Columbia River Crossing

**Comments re: EIS for CRC**

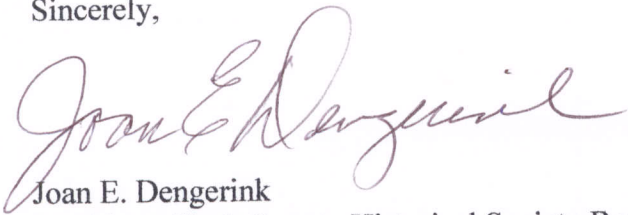
5. **Setting:** If the light rail option selected involves removal of a section of sidewalk and land on the north side of the building along with installation of a barrier between the transit system and the Museum, the board is concerned about access for our patrons.

The Museum must be visible to the community to encourage use of the facility. The Museum also depends on admission fees for operations. If the Museum is not able to remain open during construction it will be detrimental to our future.
